SOUTH CAMBRIDGESHIRE DISTRICT COUNCIL

REPORT TO: Planning Committee

Discharge of Conditions - Cambridgeshire Guided Busway

TITLE
 B1050 LONGSTANTON JUNCTION
 DISCHARGE OF PLANNING CONDITIONS
 GENERAL LANDSCAPE LAYOUT

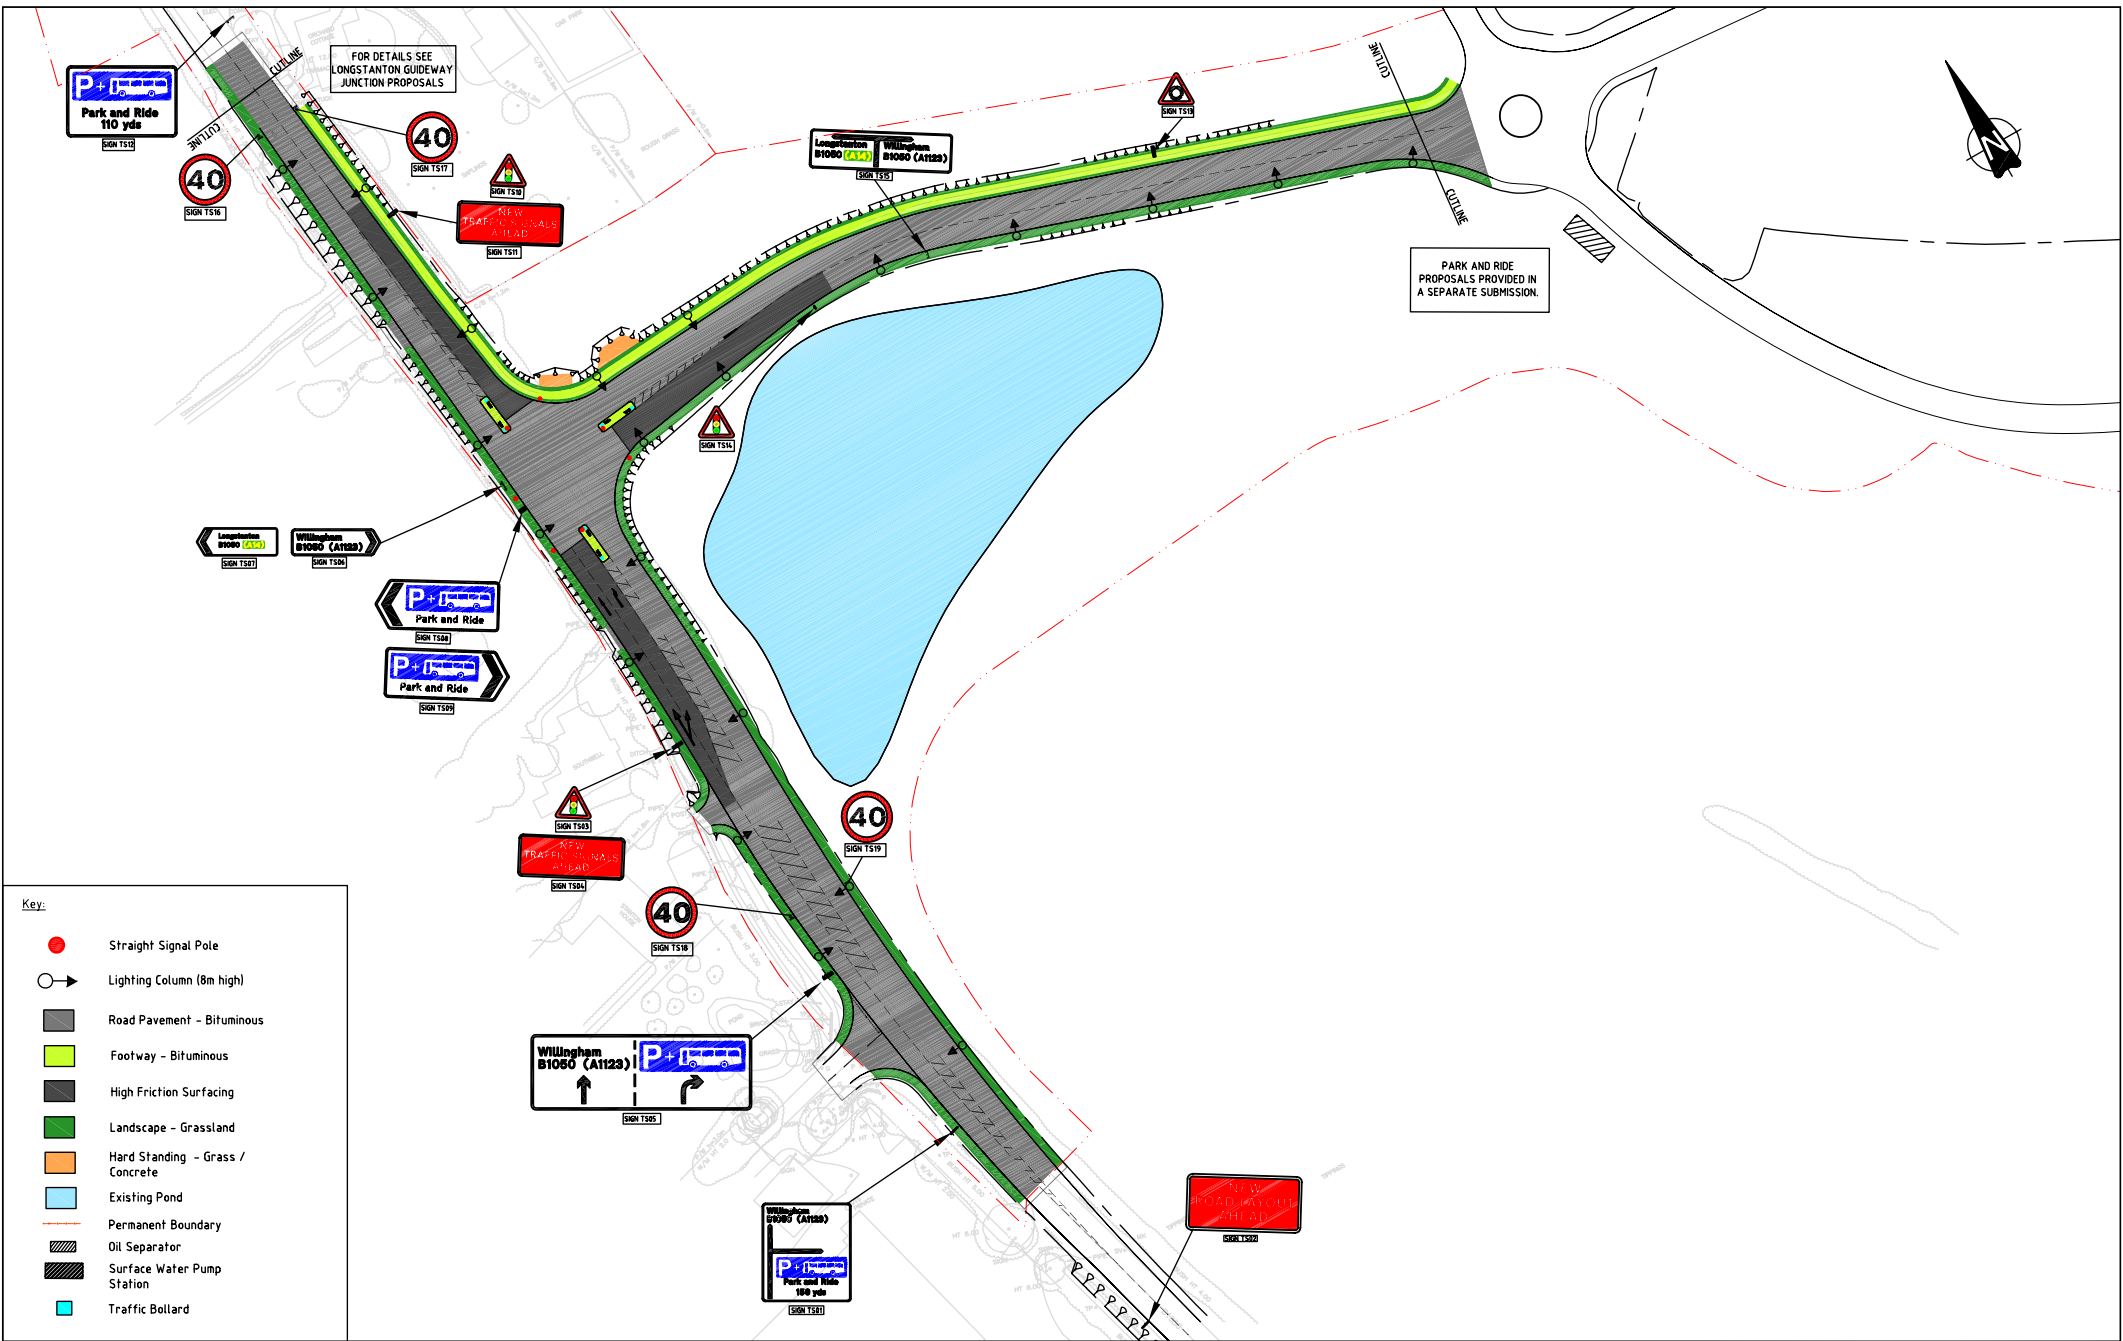
- (e) Proposed low level landscaping to replace a hedge separating “Stanton House” and “Southwell” from the Park and Ride site would prejudice road safety (snow drift), cause loss of an eastern windbreak, loss of a visual shield from the development and damage established hedge ecology. A replacement hedge of the same height as currently should be planted.

- (k) Insufficient details have been provided for drainage arrangements to the two properties. There is no explanation of how the surface water pumping station will work on the Park and Ride site.

- (p) There are many signs for the Park and Ride site.
 - (q) Planting to the west of the balancing pond is limited to grassland and wildflowers. This should include native tree planting to protect these properties.

32. Landscaping issues have been discussed in considerable detail between the CGB Team and the Council's officers. The scheme has been amended to reflect those discussions. To assimilate the development in the short-term, the most sensitive boundary will be to the south west, where native screen planting is proposed. It will, continue along the south boundary of the balancing lake and to the east of Station Road for a distance of some 75 metres. However, I agree that it would be desirable to achieve some native tree planting or replacement hedgerow in the 6m-10m wide belt between the B1050 and the balancing lake. I have requested the scheme incorporate this additional planting. In the longer term the combination of maturing vegetation and development at Northstowe will satisfactorily screen the development. Some evergreen species would be welcomed.

42. A. It is recommended that condition 3(a)(vi) be discharged in regard to the design and external appearance for the Longstanton Park and Ride site in accordance with the amended drawings submitted by letters dated 8th November 2007 and 20th March 2008 subject to agreement being reached on a timescale for the completion of the dedicated bus, foot and cycleway connection to Northstowe, the use of full cut off luminaries in accordance with the recommendations of the Institute of Lighting Engineers and revisions to planting proposals between the balancing pond and the B1050.

**B1050 LONGSTANTON JUNCTION
DISCHARGE OF PLANNING
CONDITIONS
GENERAL LAYOUT**

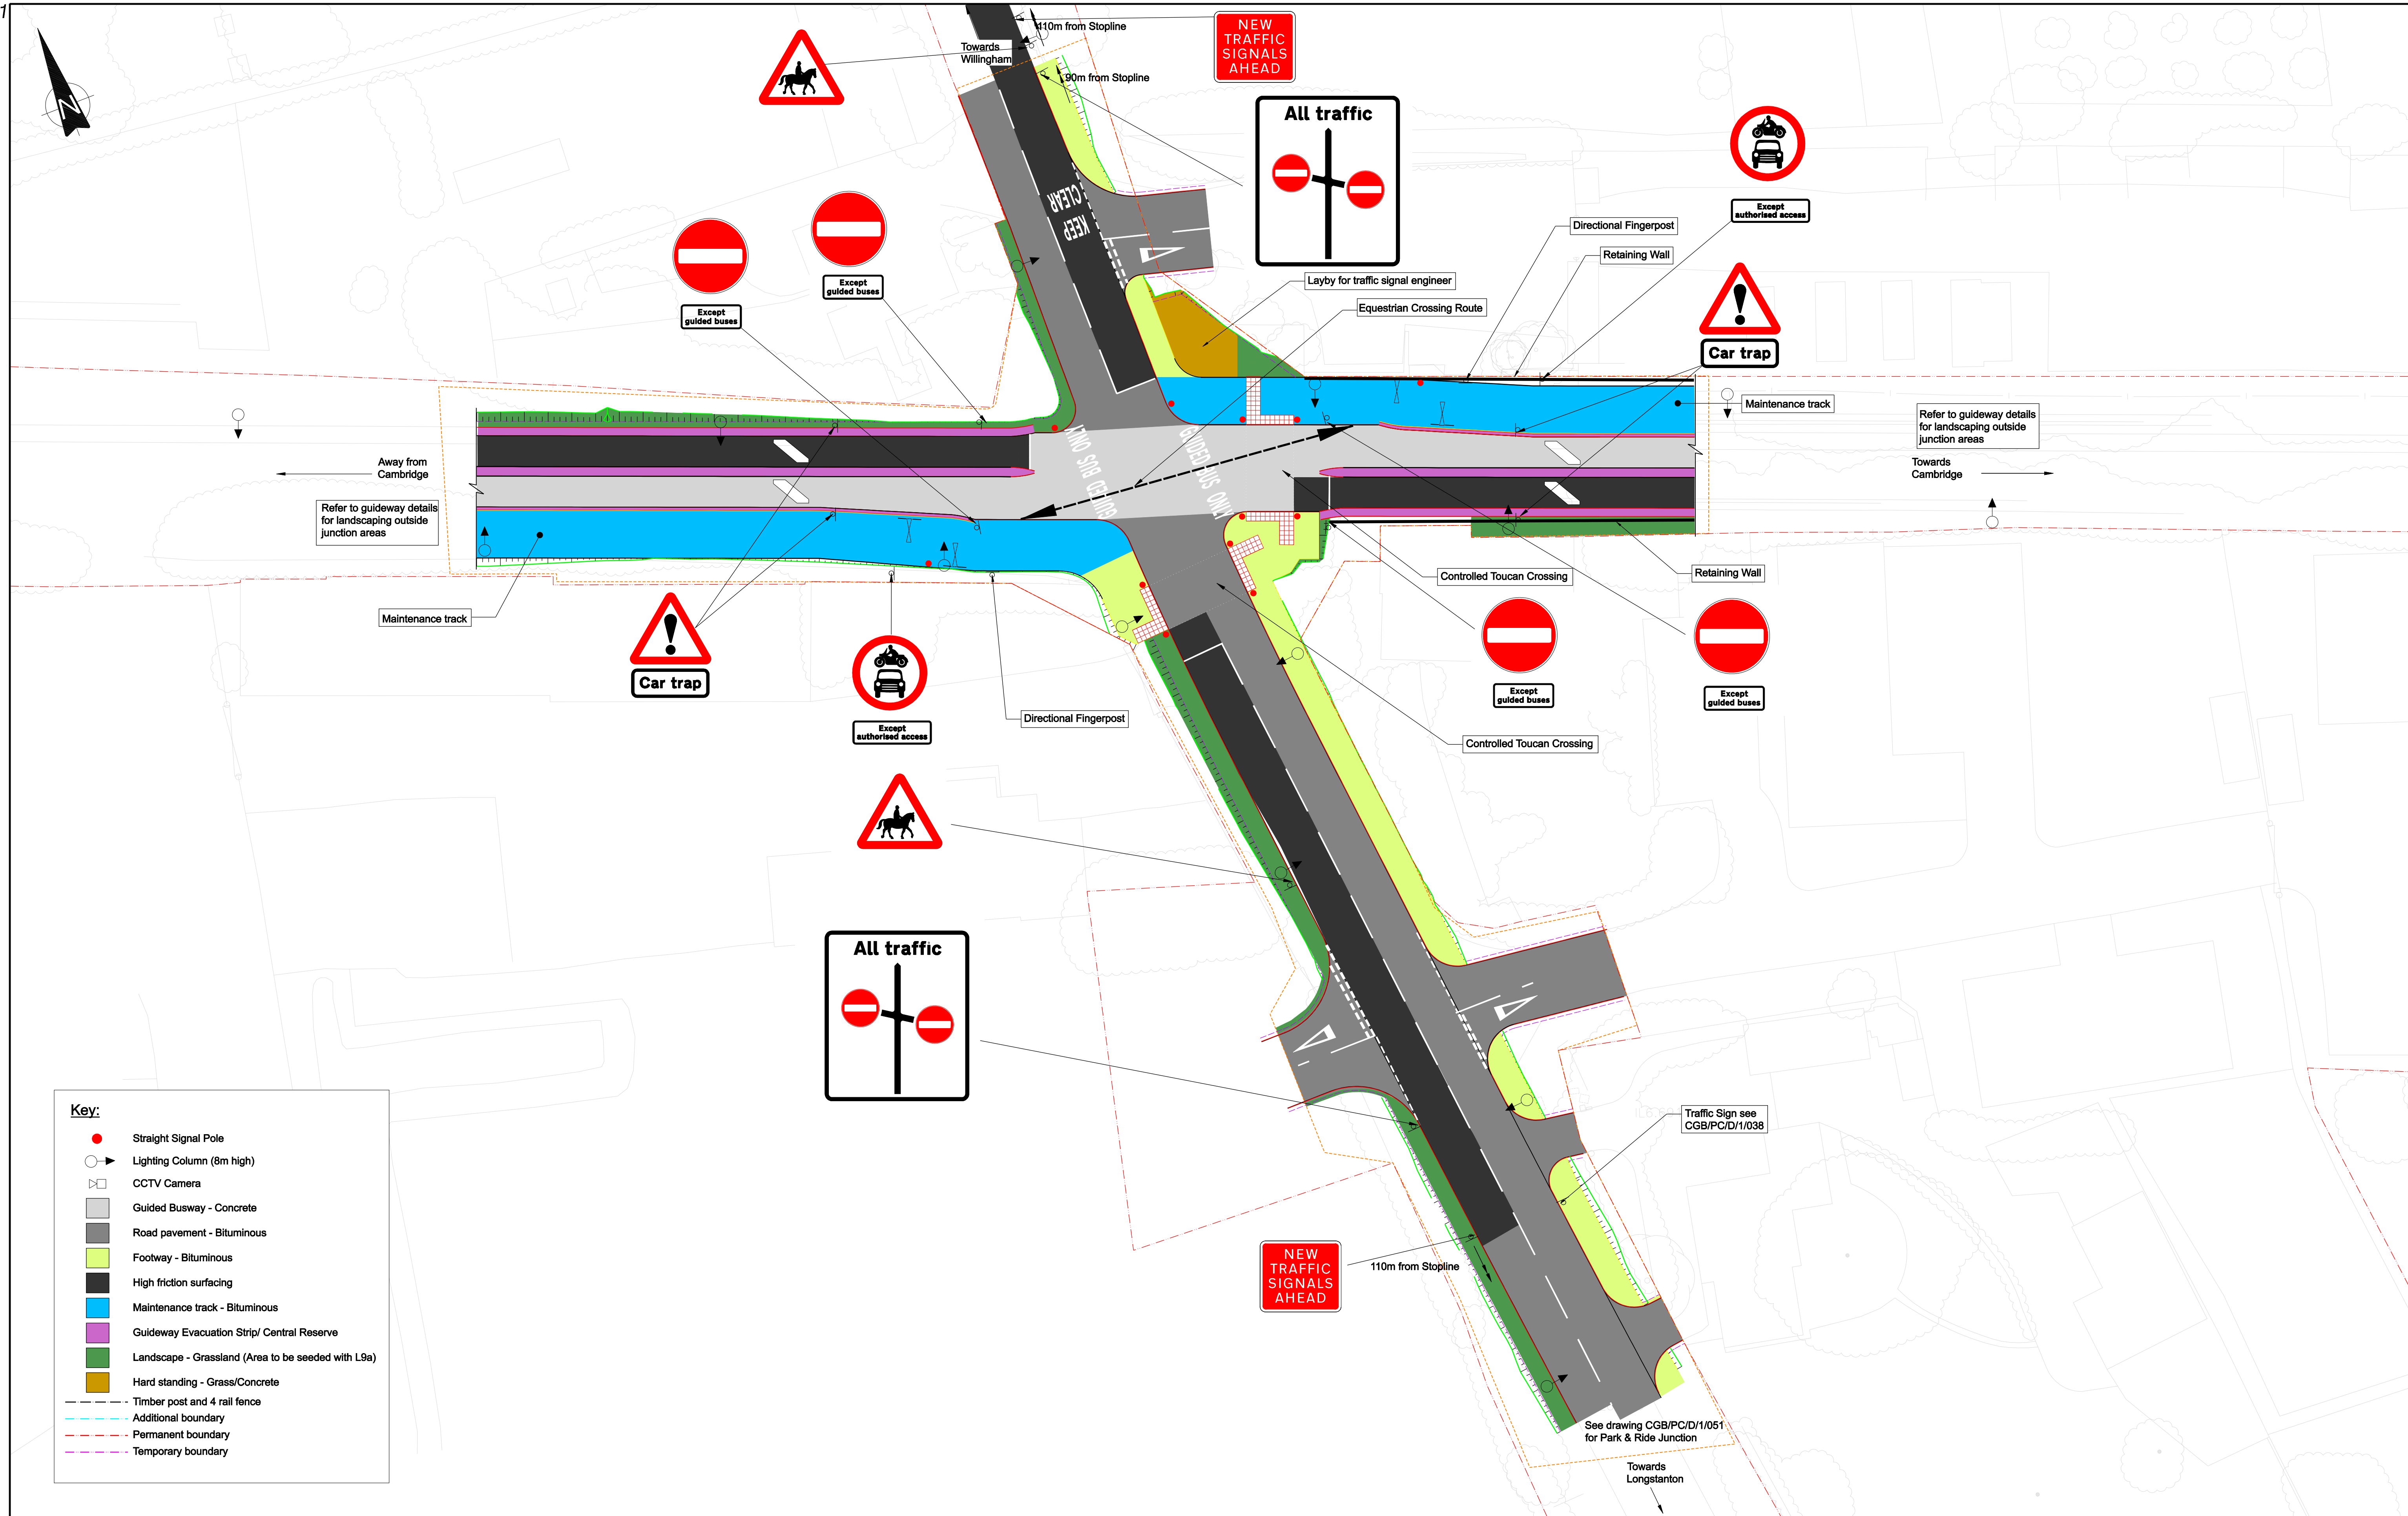
- (a) “The new junction shows limited access to and from the property of Mrs Kides (Southwell). Mrs Kides has operated a small retail business from her property for over 30 years, and is dependent upon the income she generates. The Parish Council is concerned that limited access to Southwell raises road safety concerns for Mrs Kides, pedestrians and drivers.

- (b) Access to and from the Stanton House property may be limited at peak hours by vehicles using the traffic lane turning right into the Park and Ride creating a queue of stationary traffic across the property entrance.

- (c) The junction access to the depot of John Henry Ltd off the new roundabout will create additional heavy traffic flow, noise and pollution risks.
- (d) Road drainage is currently provided by cut ground culverts. The proposed plan makes no reference to the ditch on the West side. The Parish Council requires clarification that if kerbstones are used to edge the road what is proposed to address the drainage?

- (e) The Parish Council is unclear as to what exactly ‘Permitted Deviation’ refers. This matter appears to affect the properties on the West side. We require further information in order to comment.

- (n) The plans show an outline of 'Permitted Deviation', which needs explaining as it seems to cut into the properties on the west side.
 - (o) The proposed 40 mph speed limit should be reduced to 30mph due to the re-alignment of the road and the provision of three sets of traffic lights in such a short distance.

25. In regard to the amended Park and Ride scheme, Gallagher Estates, supported by English Partnerships, states:
- “I have the following comment to make; it appears from the Drawing “B1050 Longstanton Junction Discharge of Planning Conditions General Layout” (Drawing No. CGB/HJY/JNLONA/D/1/091/A) that new footways are only proposed on the north side of the new access road into the CGB Park and Ride and north of the junction of the access road and the B1050. Because of the presence of existing homes and residences south of this junction along the B1050, and taking into account Longstanton village as a whole and the new Home Farm development, we would suggest that footway/cycleway provision needs to be extended ideally on both sides of the B1050 south of the new junction being formed”.

26. The Guided Bus Team has responded to a number of issues raised by consultees as follows:
- (a) Access to/from “Southwell”: It is not possible to widen the highway any more than that proposed due to the available land width to the north of the Park and Ride junction. Widening the northbound carriageway at Mrs Kides’ entrance will have an adverse affect on the traffic flow through the junction on the southbound side of the B1050.

- (b) Access to/from “Stanton House”: It is anticipated that the junction traffic signals will, in fact, improve the safe access to and from Stanton House by slowing the flow of traffic. It is widely acknowledged that slow moving or queuing traffic can assist vehicles wishing to exit such properties during busy periods. An independent Road Safety Audit process is being undertaken to formally assess the safety issues of the revised highway layout.

- (d) Road Drainage: The current western drainage ditch will not change in its current position or function to the south of “Southwell” as a result of the work. However, the ditch to the north of “Southwell” will be pipe culverted over a 60m+ length to permit construction of the new carriageway. Highway drainage arrangements will be to the satisfaction of the Environment Agency and Awards Drain Authority.

- (e) “Permitted Deviation”: This comment is not understood. If it is referring to Limits of Deviation, these are the available land limits covered by the TWA order and are the available land limits covered by the deemed planning permission for the development.

28. The amended submission for the Park and Ride junction has successfully moved it north of the access to "Southwell". Thus the existing accesses, frontage vegetation and open drainage ditch along this property and "Stanton House" will not change, although works will be carried out to link the re-aligned carriageway to the existing access to "Stanton House". Some inconvenience will inevitably be caused to the plant stall at "Southwell" but this seems unavoidable.
